PG&E Letter DCL-08-094

Docket No. 50-275, OL-DPR-80
Docket No. 50-323, OL-DPR-82
Diablo Canyon Units 1 and 2

Response to Request for Additional Information Regarding Supplemental Response to Generic Letter 2004-02, "Potential Impact of Debris Blockage on Emergency Recirculation During Design Basis Accidents at Pressurized Water Reactors"

**RESPONSE TO NRC REQUEST FOR ADDITIONAL INFORMATION REGARDING
SUPPLEMENTAL RESPONSE TO GENERIC LETTER (GL) 2004-02, "POTENTIAL
IMPACT OF DEBRIS BLOCKAGE ON EMERGENCY RECIRCULATION DURING
DESIGN BASIS ACCIDENTS AT PRESSURIZED WATER REACTORS"**

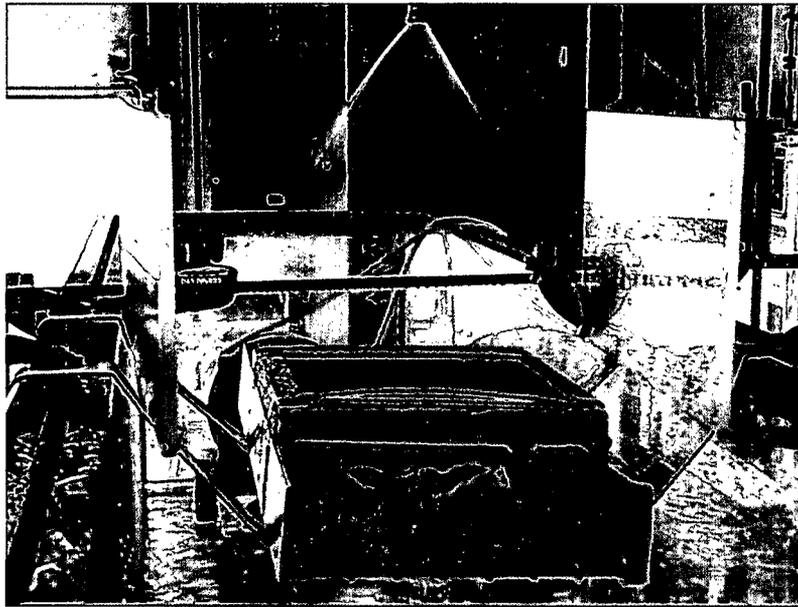
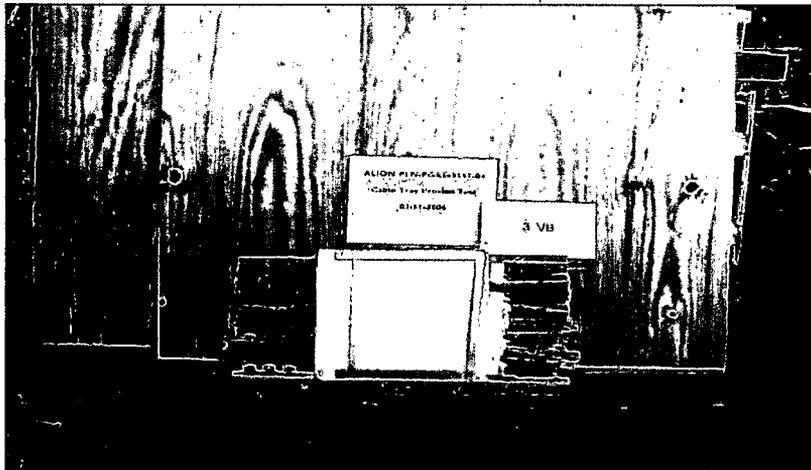
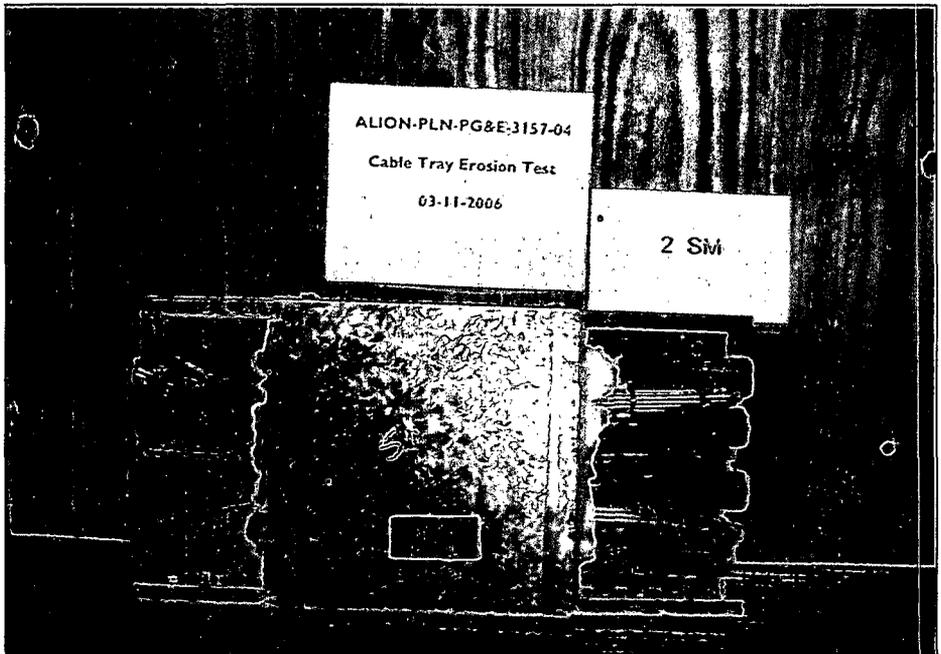
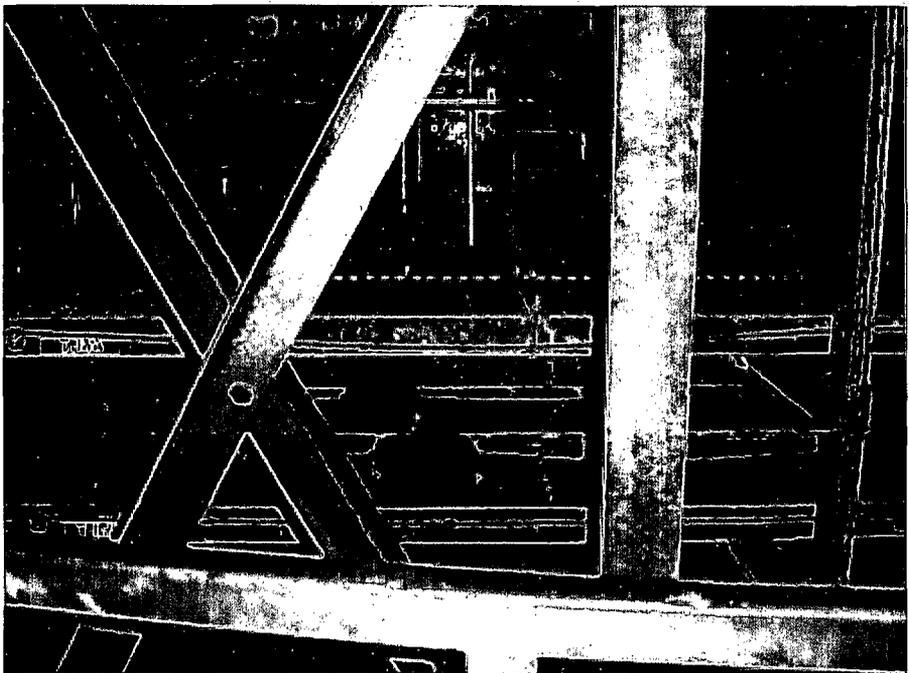
Please state whether the fire stops and unjacketed debris in containment outside the crane wall would be exposed to the runoff of spray drainage streams, and state whether this effect was accounted for in the erosion testing that was performed on these materials (as opposed to assuming that all spray flow was in the form of fine droplets).

The actual field installation of the horizontal cable tray cover would be the length of the cable tray that passes under stairways, hatches, and gratings (see Figure 4). The actual installation of the horizontal cable tray cover would envelop the entire fire stop

without exposing any of the damming material. The purpose of the cable tray cover is to protect the cables from any objects that could fall through the opening of the hatches and gratings above. Cable trays are often installed in stacks of two or more trays. In this case the lower cable trays are not installed with covers as the cable tray above would afford protection. Walkdowns were performed of the Unit 1 and Unit 2 containments to determine the type (vertical or horizontal and width) and the number of fire stops that would be susceptible to erosion due to the action of containment spray. The identified fire stops were in cable trays that were generally underneath grating and near stairways and hatches. The top cable tray in these areas would have a cover. If the identified fire stop did not have a cover it was because the fire stop was installed in a cable tray that was underneath another cable tray.

The erosion testing for the horizontal cable tray fire stops is conservative in that the covered fire stop specimen conservatively exposes the ends of the fire stop material to the erosion of the containment spray whereas the installed configuration has the fire stop completely covered. Also, the uncovered fire stop specimens were tested with direct spray; whereas the installed uncovered fire stops are afforded protection from the containment spray by the cable trays installed above. In both of these configurations, covered or uncovered cable trays, the fire stops would not be exposed to runoff or spray drainage streams as they are protected by the cable tray cover or the cable tray above.

Figure 1 – Test Tank Showing Agitators

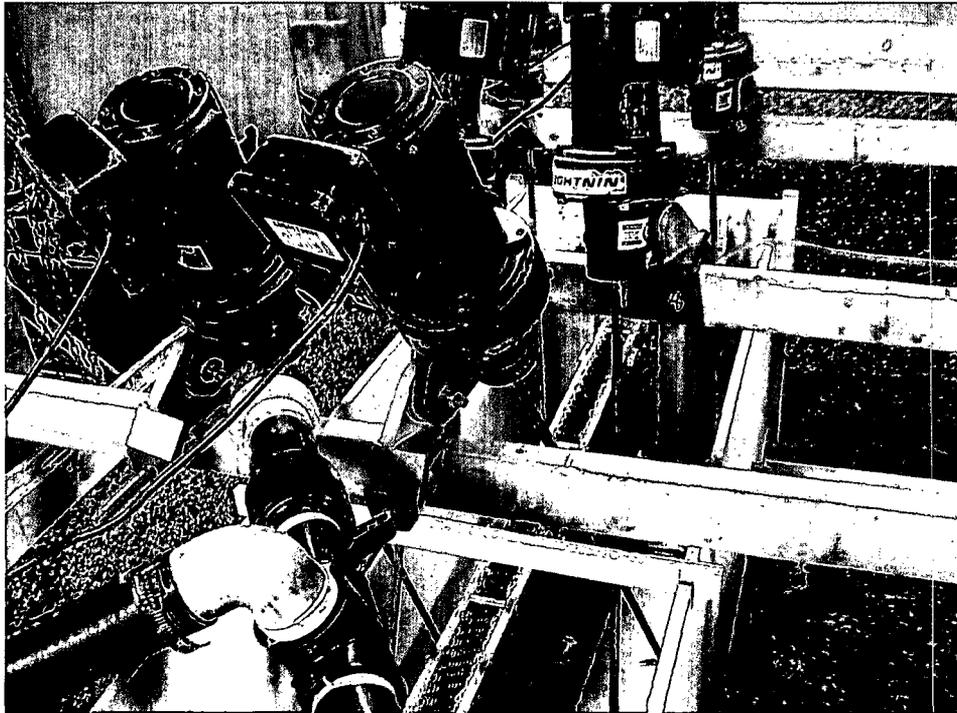
Please provide an evaluation that shows that the stirring in the tank to prevent debris settling did not affect the formation of the strainer debris bed in a non-prototypical or non-conservative manner (prevention or wash away of debris beds, or disturbance of the debris bed by non-prototypical intrusion of paint chips or large pieces of fiber).

A total of six motor driven agitators were used for each sector head loss test. The agitators were placed as follows (see Figure 1):

- 2 agitators vertically down, one on each side of the plenum
- 2 agitators crossed at approximately 60 degrees down on each side of the sector test article. The propellers on these 4 agitators were approximately 6 inches from the floor of the test tank.

Figure 1 - Test 14-S-PSG, and 15-S-PSG Head Loss Testing Results

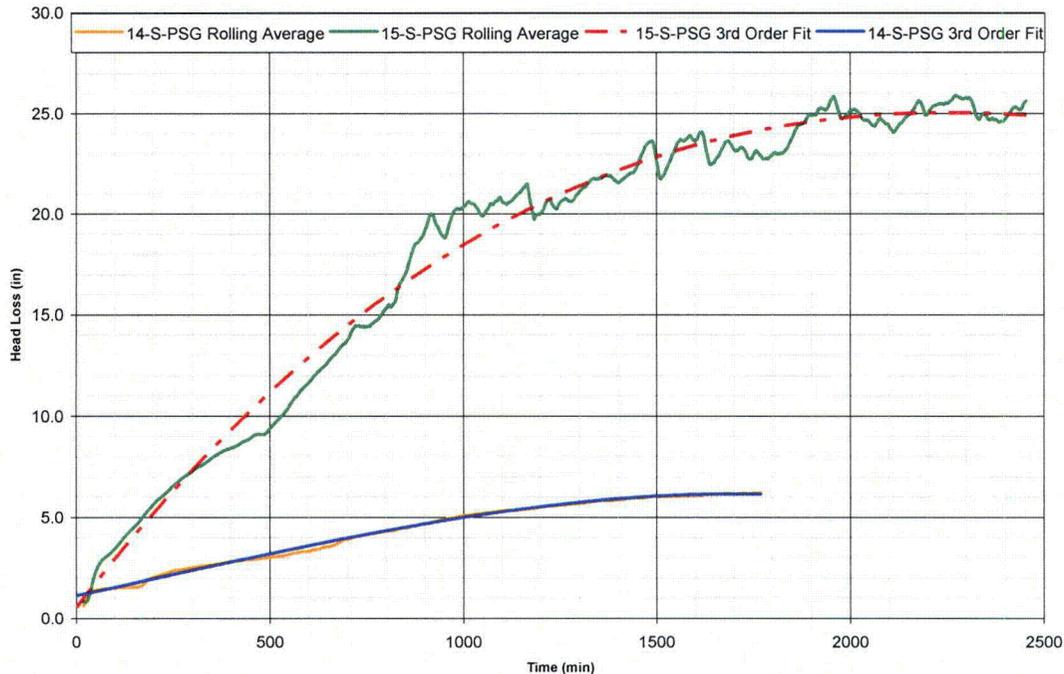
Please provide a basis for not performing a time-based extrapolation of the test data out to the emergency core cooling system (ECCS) mission time. [The staff understands that the integrated chemical head loss test was run for the number of fluid turnovers that would occur in the plant. However, there are potential time-based debris bed change mechanisms that could result in additional head loss (e.g., compaction). It has been observed in testing, after many test rig fluid volume turnovers, that after particulate debris has been filtered from the water the strainer head loss continues to increase with time.]

DCPD's head loss tests are continued for at least 24 hours after the last addition of chemicals. The amount of fiber debris has been limited based upon the extensive debris mitigation efforts. After this limited amount of fiber and/or paint chip debris has formed a debris bed (less than 100 percent coverage of the screens), a portion of the chemical and particulate debris will adhere to the fiber and/or paint chip bed and essentially block this portion of the screen area. Where there is open screen area the remaining chemical and particulate debris would pass through the screen without causing additional head loss. The resulting head loss observed is due to the flow across the limited open screen area. The turbidity of the test flume did not decrease after the debris bed was saturated with all of the chemical and particulate debris that it could absorb and the remaining chemical and particulate debris continued to be recirculated through the open screen area. At that time there is no further increase in head loss; in fact, a slight decrease in head loss was observed during some of the tests. Any extrapolation of data at the test termination point would be expected to essentially be a straight, flat line (see Figure 1).

Figure 1 - Cold Leg Recirculation Flow Path

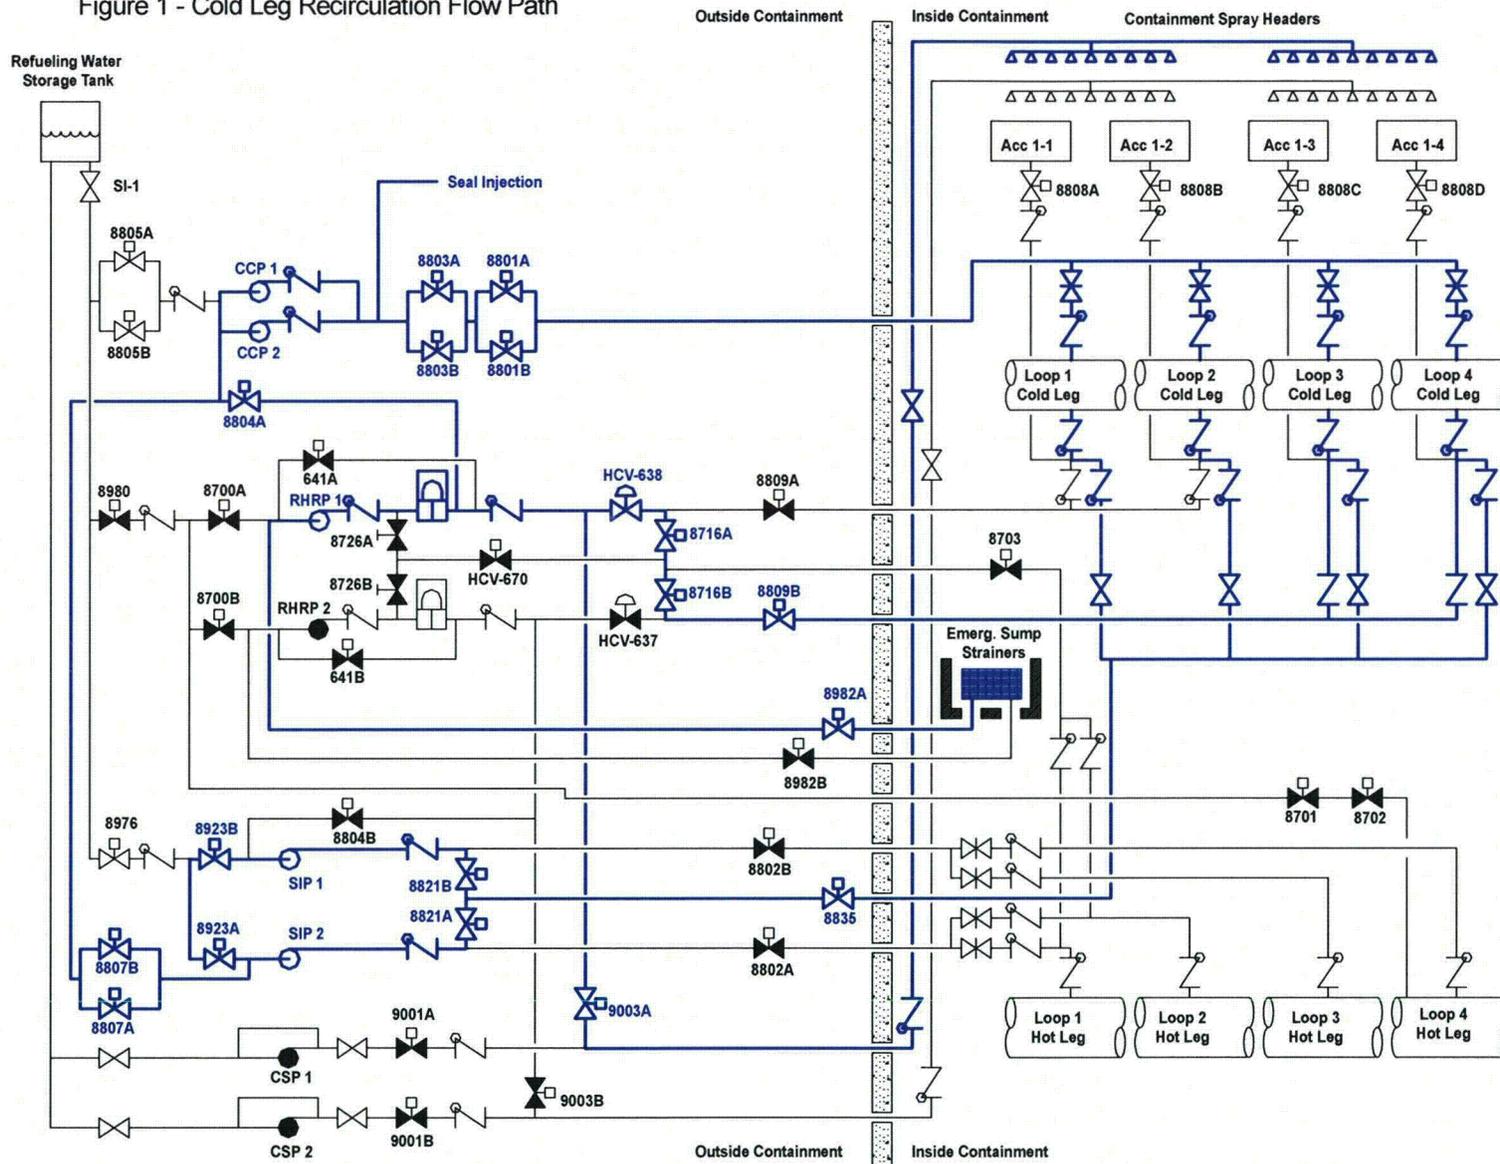
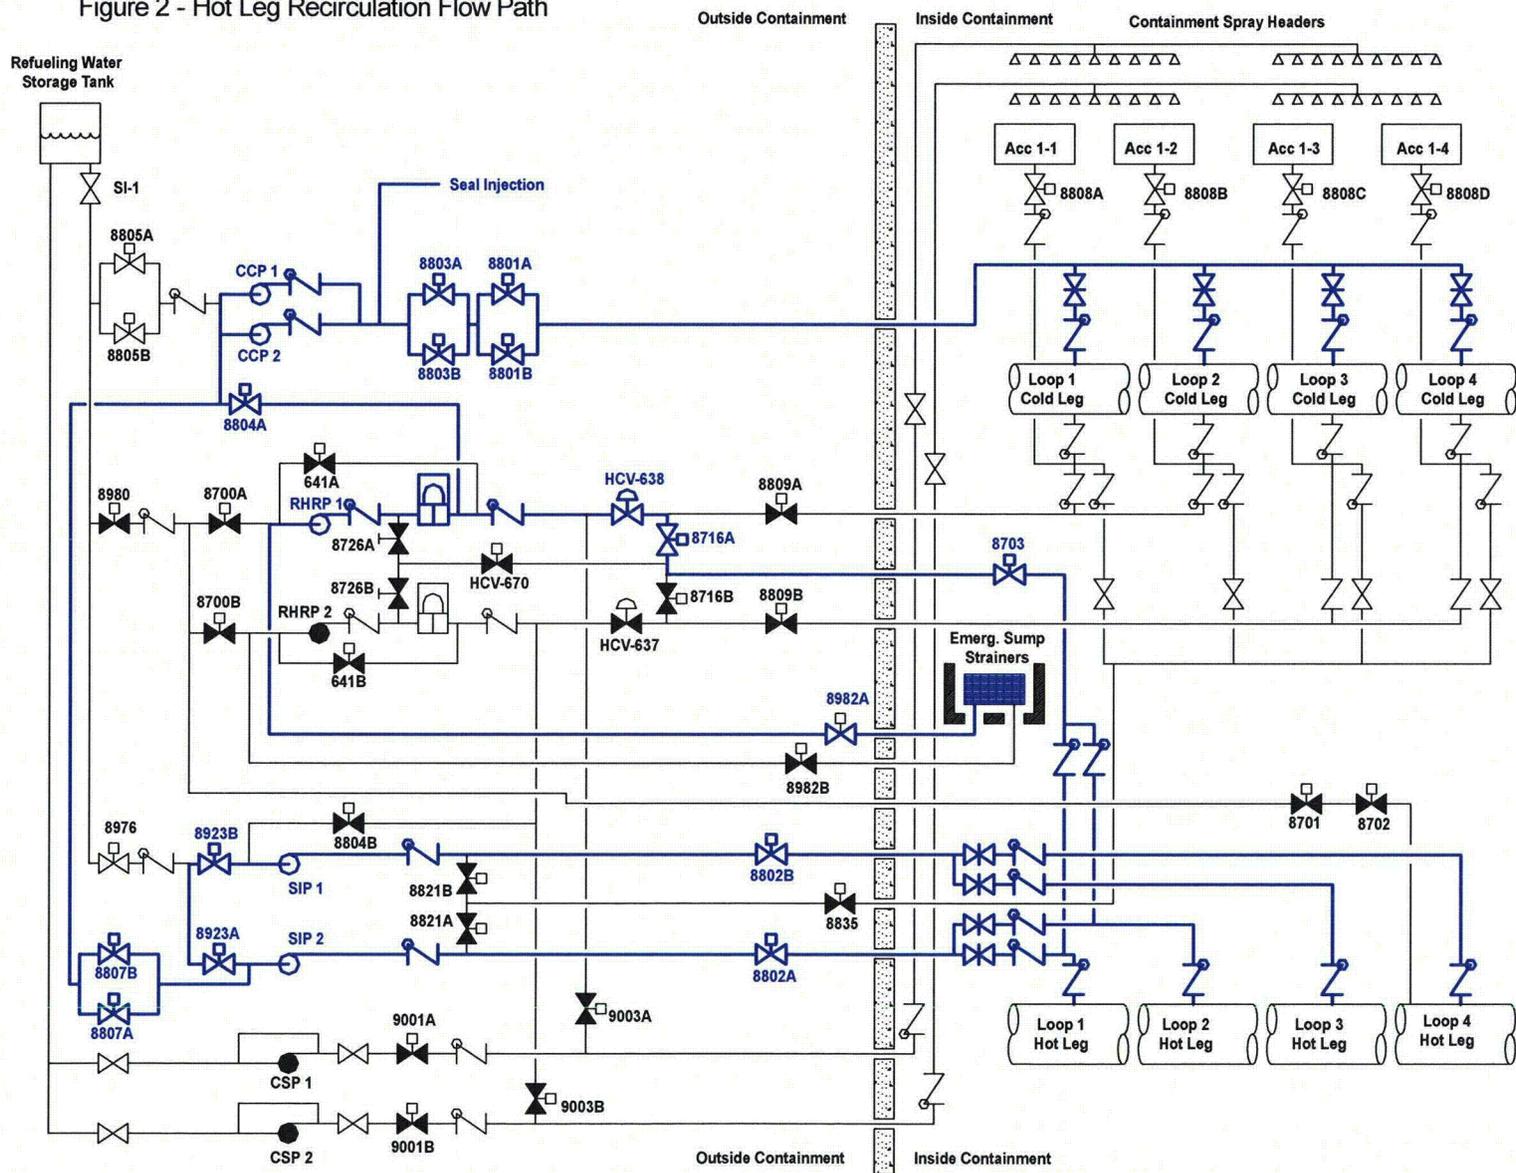
Please provide justification for the computed limiting ECCS flow rate being "worst case flow conditions." Please include a description of the methodology used to determine the maximum flow rate (e.g., runout flow from the vendor pump curve, a calculation using a standard hydraulics code, etc.), as well as a description of the assumptions and the assumed system and component configuration that provides the conservative maximum flow rate (e.g., for single pump operation, can flow cross over to downstream piping in the non-operating train?).

The flow alignments analyzed are shown in Figures 1 and 2. These figures correspond to the single pump cold-leg and hot-leg recirculation cases reported in the response to Question 12.
